**Response to NRC's Request for Additional Information by the Office of  
Nuclear Reactor Regulation for Topical Report (TR) WCAP-16747-P,  
"POLCA-T: System Analysis Code with Three-Dimensional Core Model"  
(TAC No. MD5258) (Non-Proprietary)**

October 2007

## Responses to NRC RAI's Regarding WCAP-16747-P Rev 0

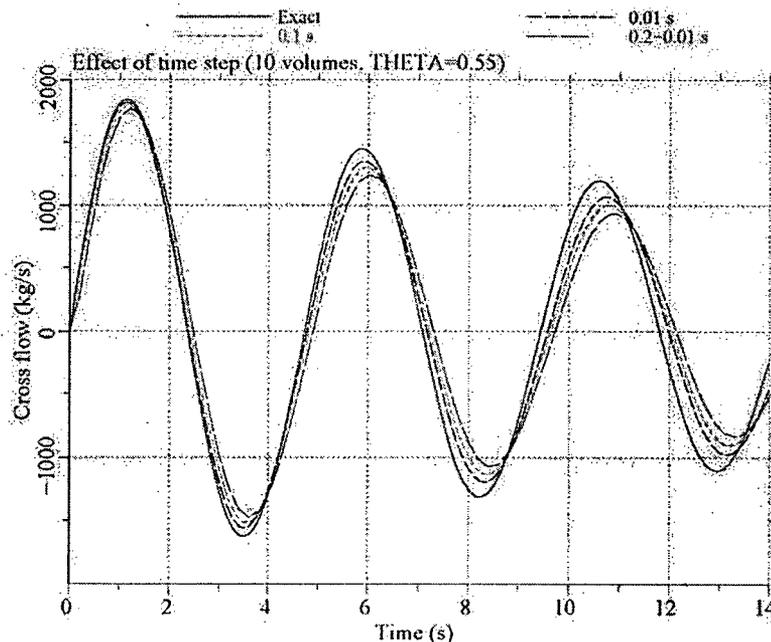
Reactor dynamic behavior is a strong function of the void reactivity dynamic feedback. Provide an estimate of the sensitivity of the void reactivity coefficient bias or uncertainty to the exposure history in terms of spectrum hardness. Specifically, provide an estimate of the void reactivity coefficient bias and uncertainty predicated on nuclear parameter determinations under conditions typical of plants operating at OLTP conditions and re-perform this estimation for conditions at high control fractions and void fractions. Based on this assessment update Appendix B of the topical report to include provisions for use of the methodology for different operating domains or plant conditions.

The accuracy and reliability of the void and void reactivity coefficient predictions are discussed in more detail in the answers to questions 2-1 and 3-1. As explained there, in Westinghouse methodology the accuracy of individual models [ ]<sup>a,c</sup> On the other hand, [ ]<sup>a,c</sup> under realistic, relevant conditions are utilized to quantify the [ ]<sup>a,c</sup> utilized in the code package under qualification. Regarding the specific case of interest here, i.e. stability predictions, Westinghouse has access to a wide data base of stability measurements in Europe, covering real plants of different design from different plant vendors loaded with fuel of different design in cores with different mix levels. Therefore, the validation of POLCA-T for stability applications is mainly made on [ ]<sup>a,c</sup>

Effect of time step choice for 10 cells model with  $\Theta = 0.55$

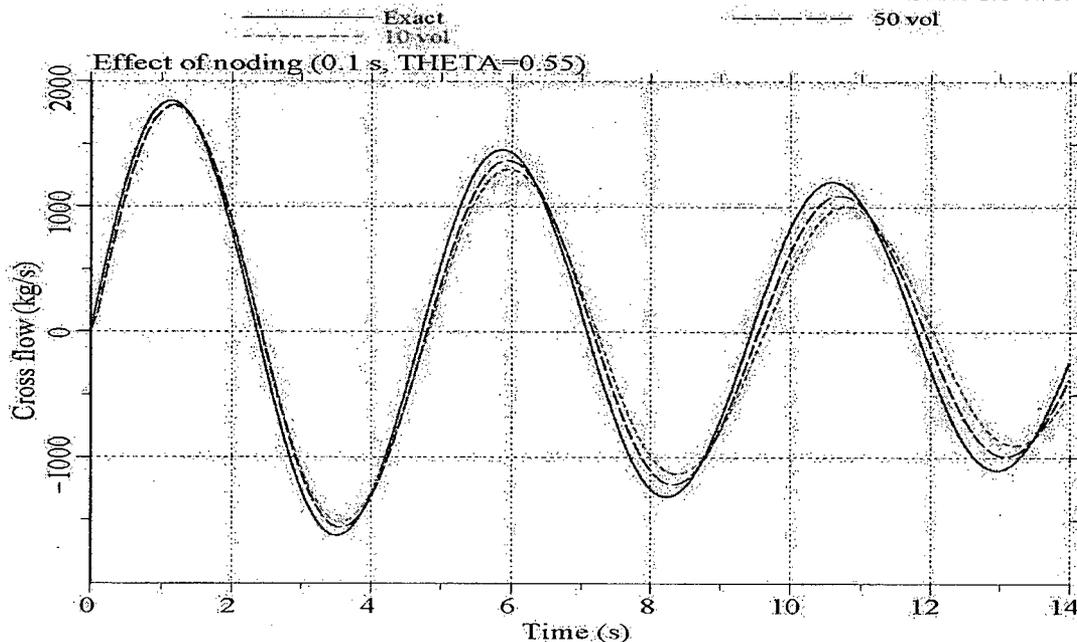
Describe the process for generating an appropriate nodalization for models used in stability analysis. Provide demonstration analyses that indicate the nodalization procedure, time step control, and numerical integration scheme do not adversely impact the numerical results of transient reactor behavior predictions. Provide a plot of the node-by-node Courant number for the hot channel for a plant included in the stability qualification based on the model used in the qualification.

The figures below show the effect of time step and effect of number of volume cells. In the responses to the RAIs 6-19 and 6-24 the effect of numerical time integration method will be demonstrated.
